SECTION 009113 – ADDENDUM ONE

- A. Project Name: 22034.02 Meridian High School Additions, Renovations and Ballfield Rebid
- B. Owner: Meridian Public School District, 1019 25th Avenue, Meridian, MS 38391
- C. Architect: Dale | Bailey, an Association, One Jackson Place, Suite 250, 188 East Capitol Street, Jackson, MS 39201-2100
- D. Architect Project Number: 22034.02
- E. Date of Addendum One: 5 January 2024

1.4 REVISIONS TO DRAWINGS

6 EXTERIOR SECTION AT PRESSBOX/ CONCESSION

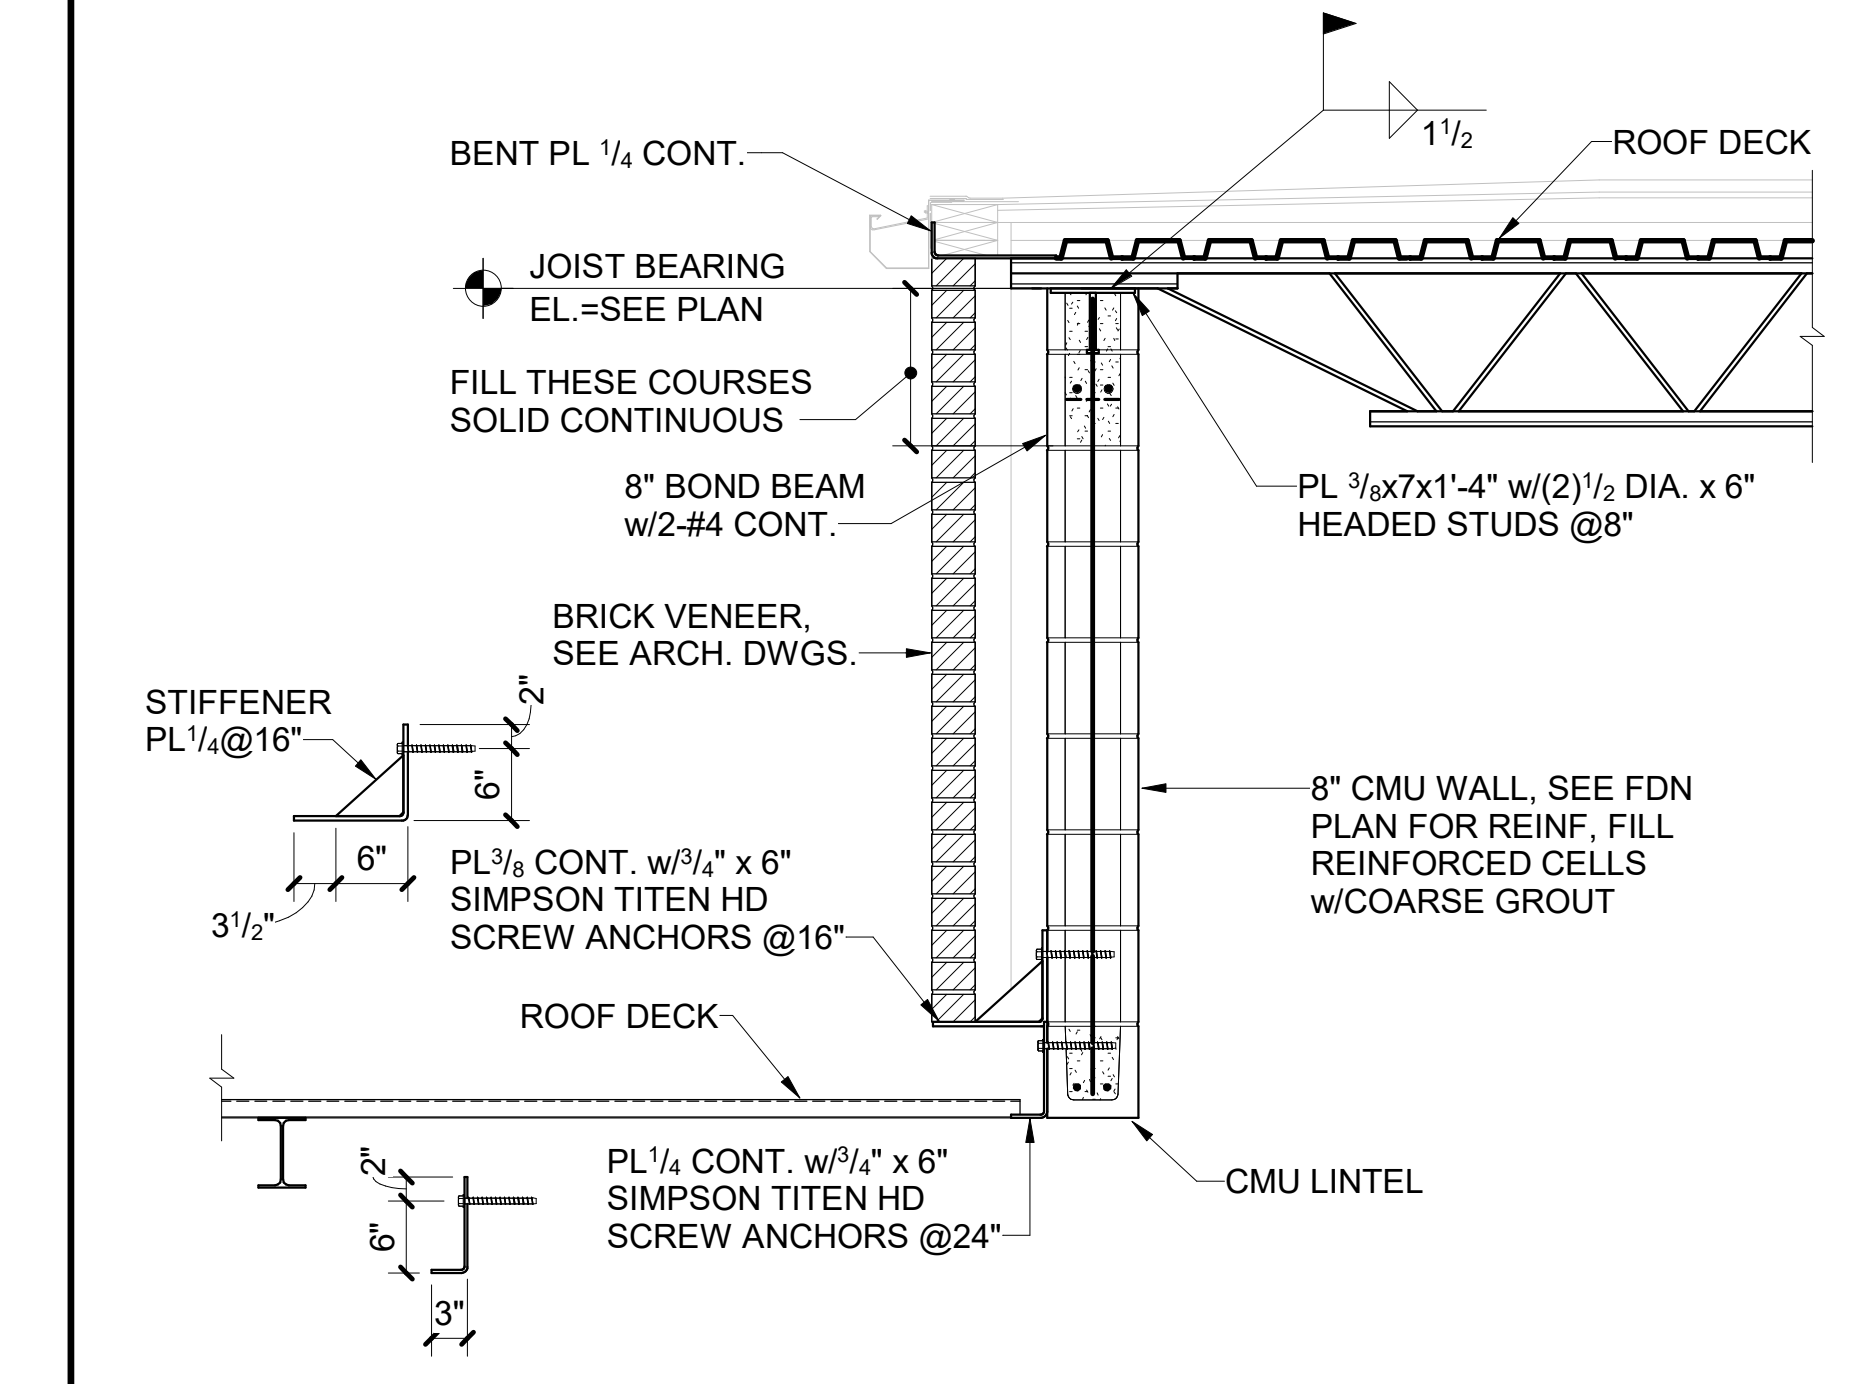
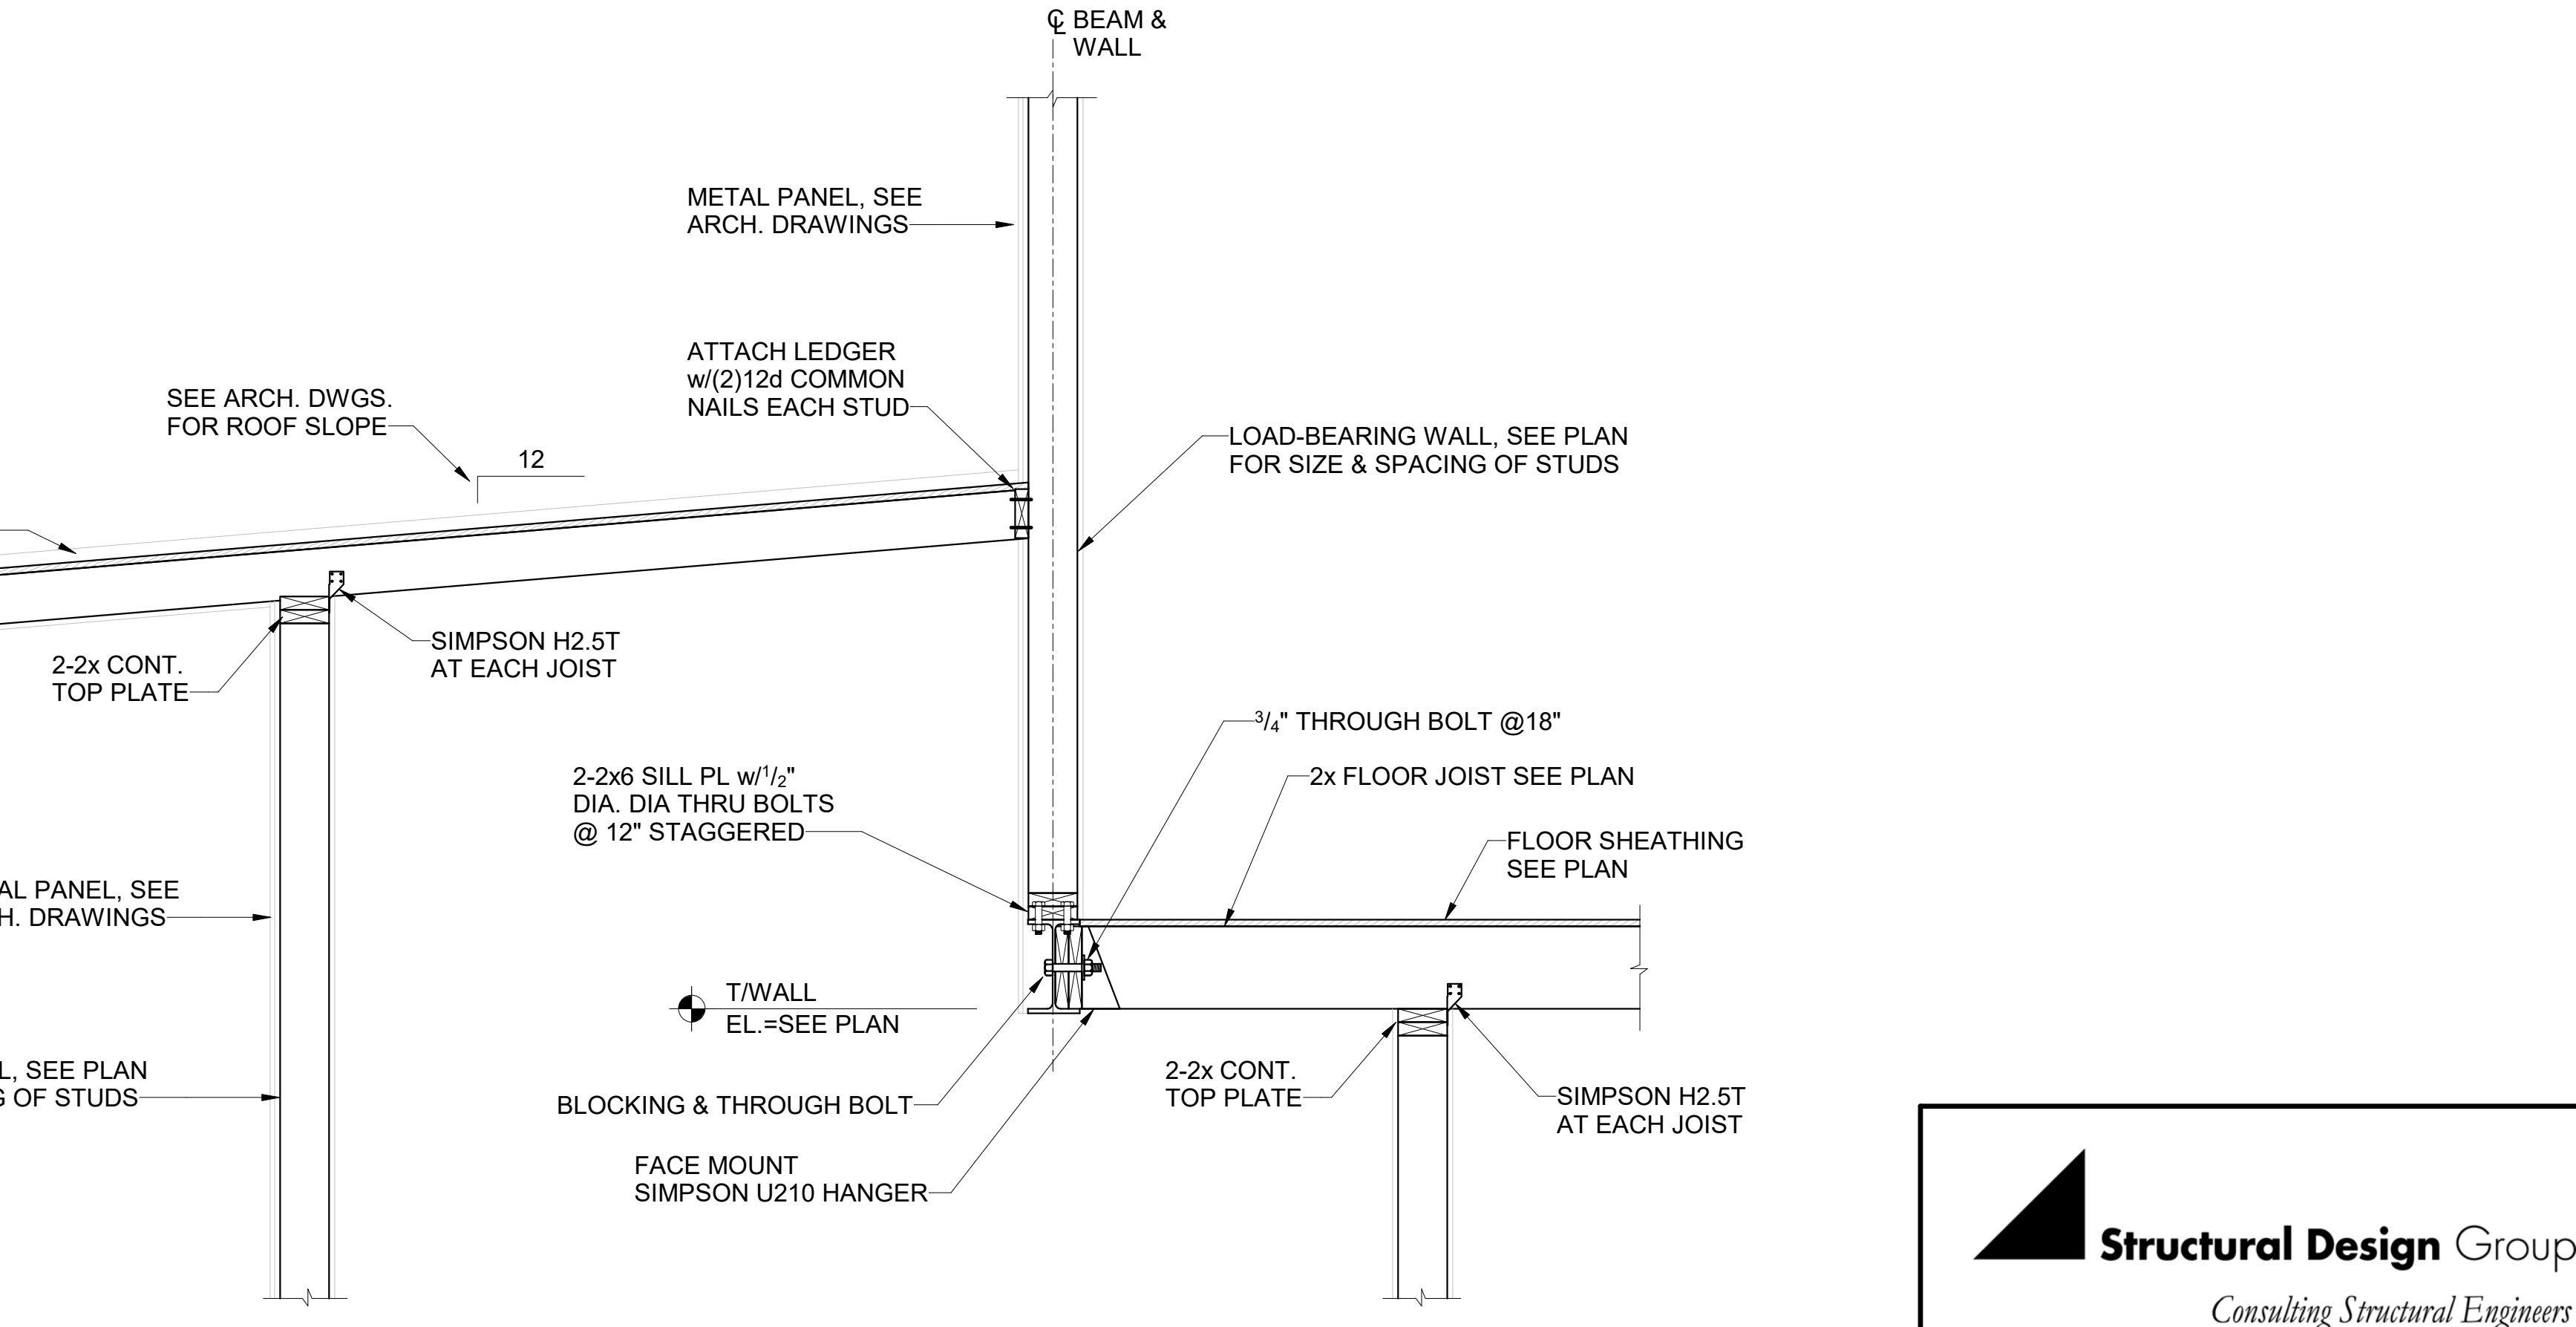
- E. Sheet S-402 (Revised). Updated detail at edge of pressbox and ramp
- F. Sheet S-403 (Revised). New details for pressbox ramp.
- G. Sheet C-200 (Revised). Updated to reflected additional demo items at baseball area

C-202

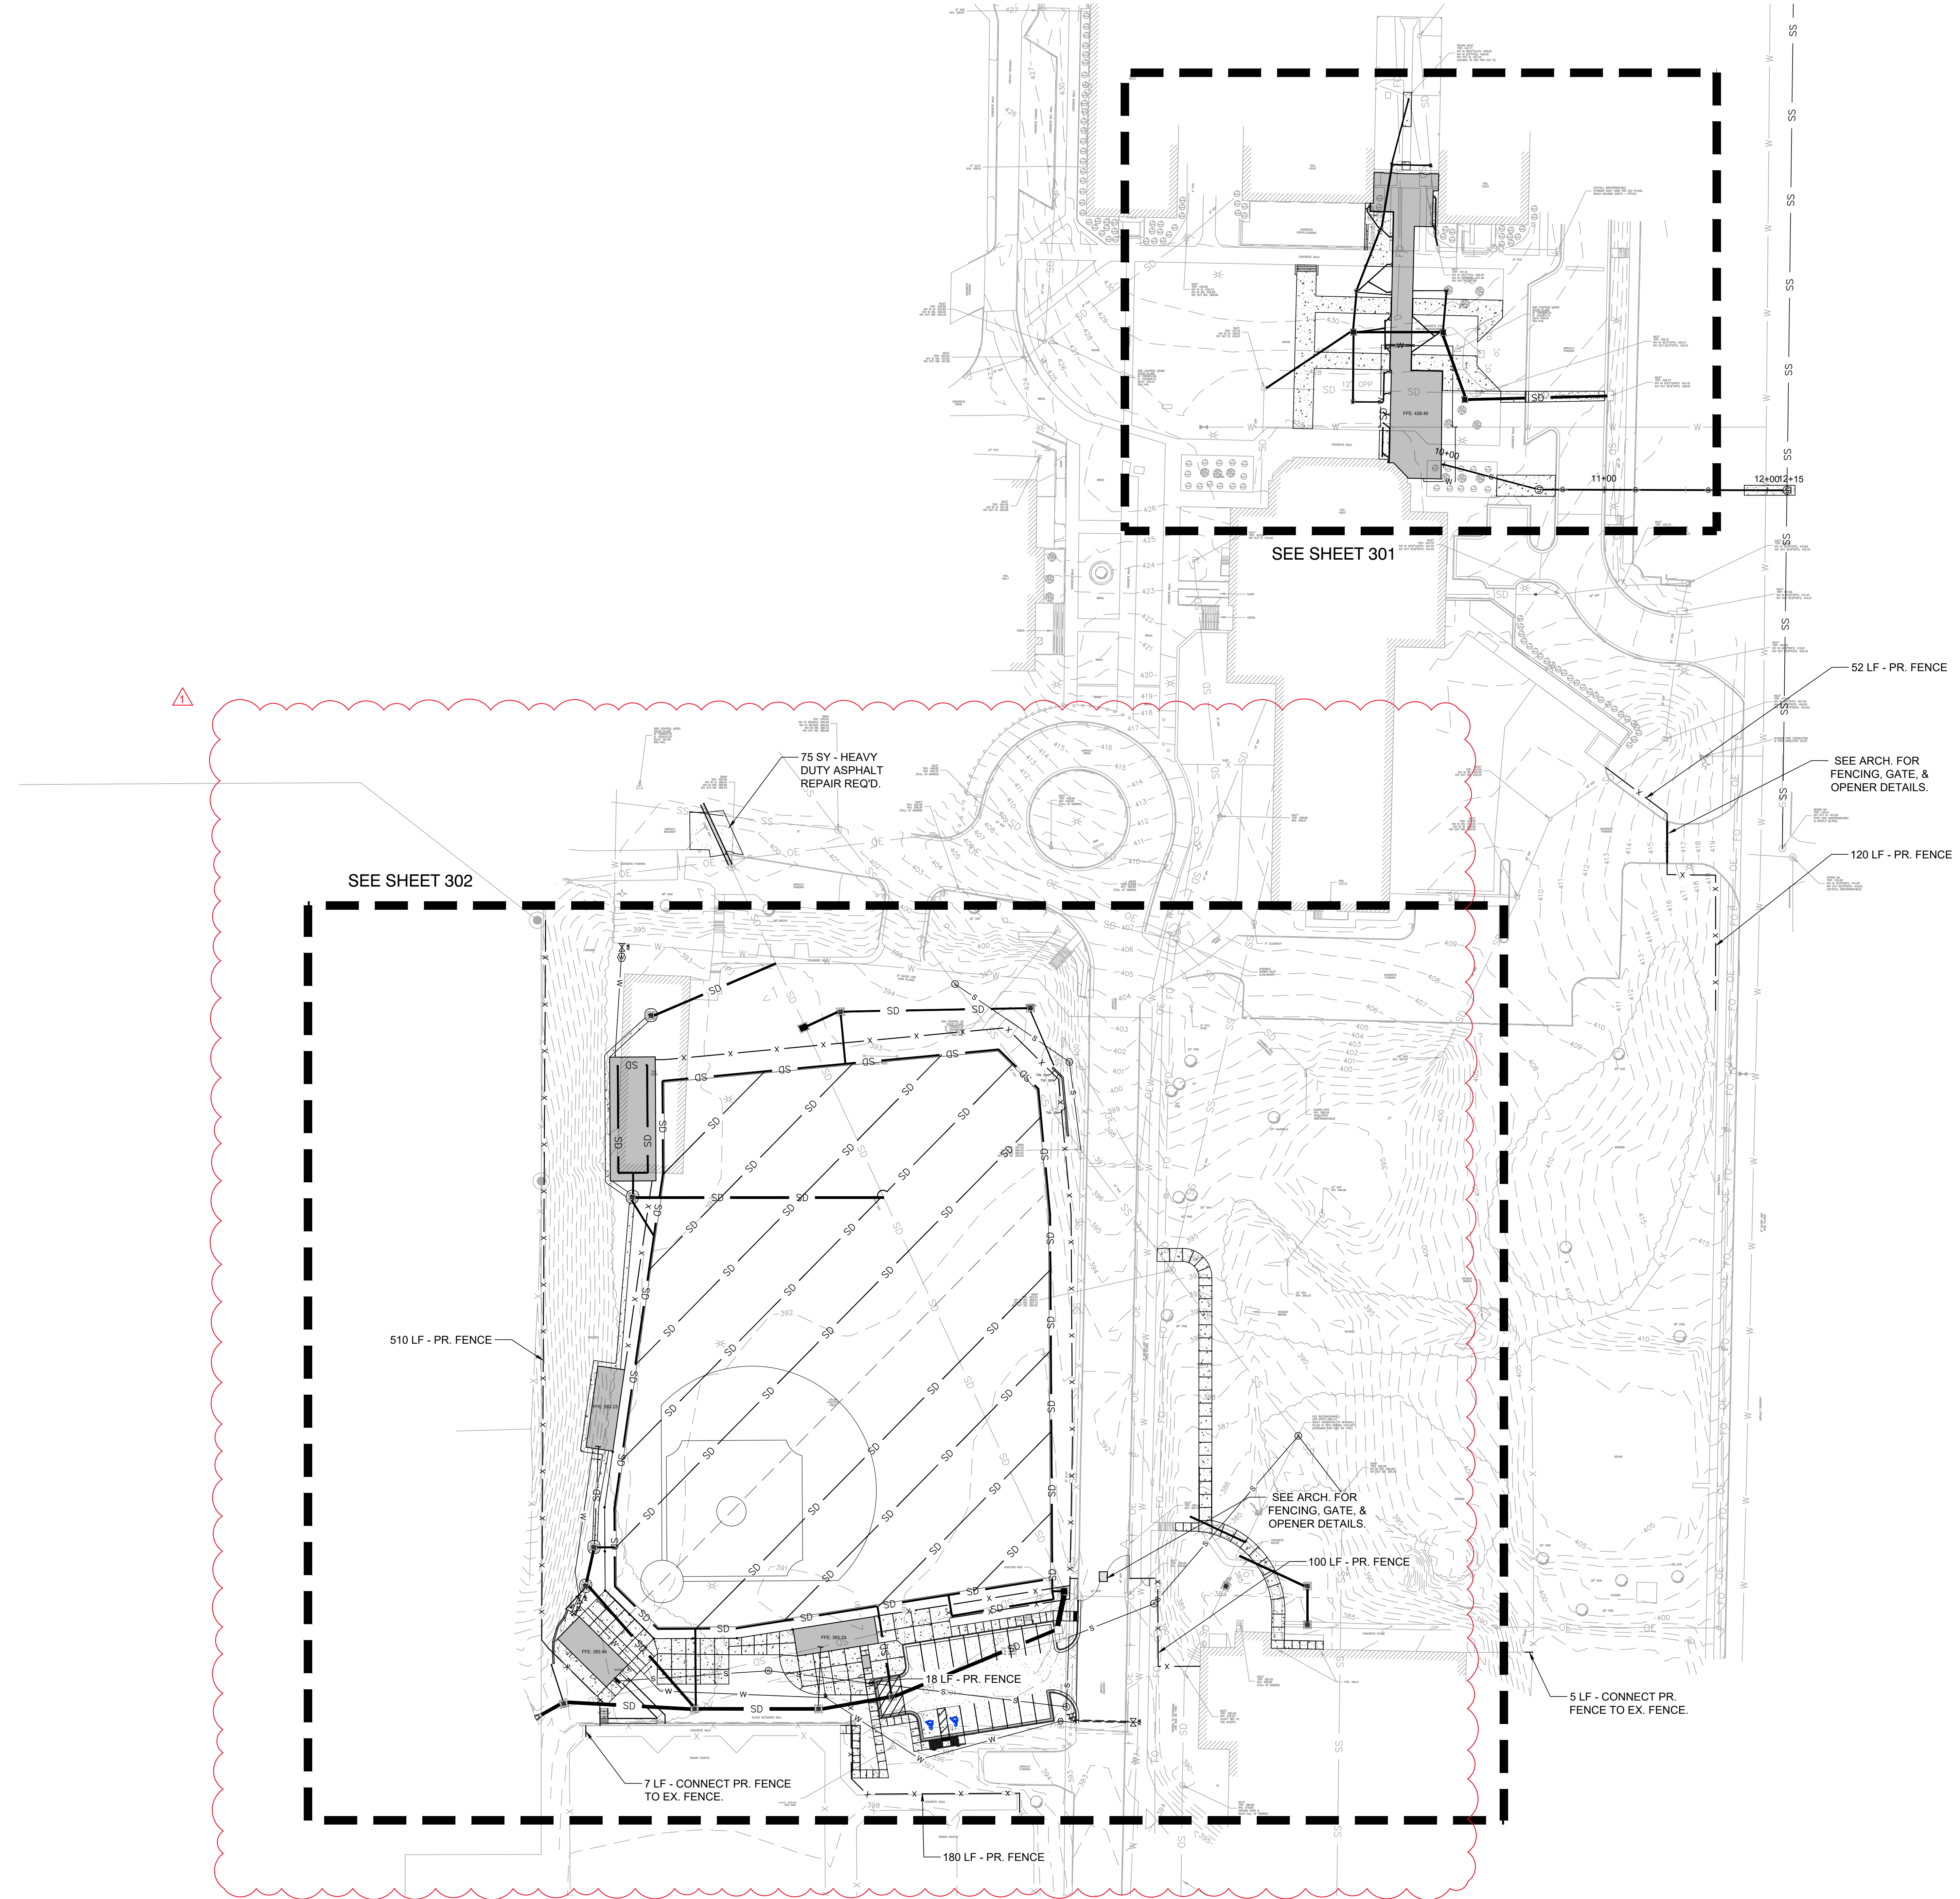
- D. QUESTION: Drawings C-202, C302, C402 and C602 are missing from the plans. Can you provide those?

- H. Sheet C-202 (New). Added sheet to reflect additional demo items at baseball area
- I. Sheet C-300 (Revised). Updated to reflect additional site items of work at baseball area

ANSWER: See attached updated civil sheets.
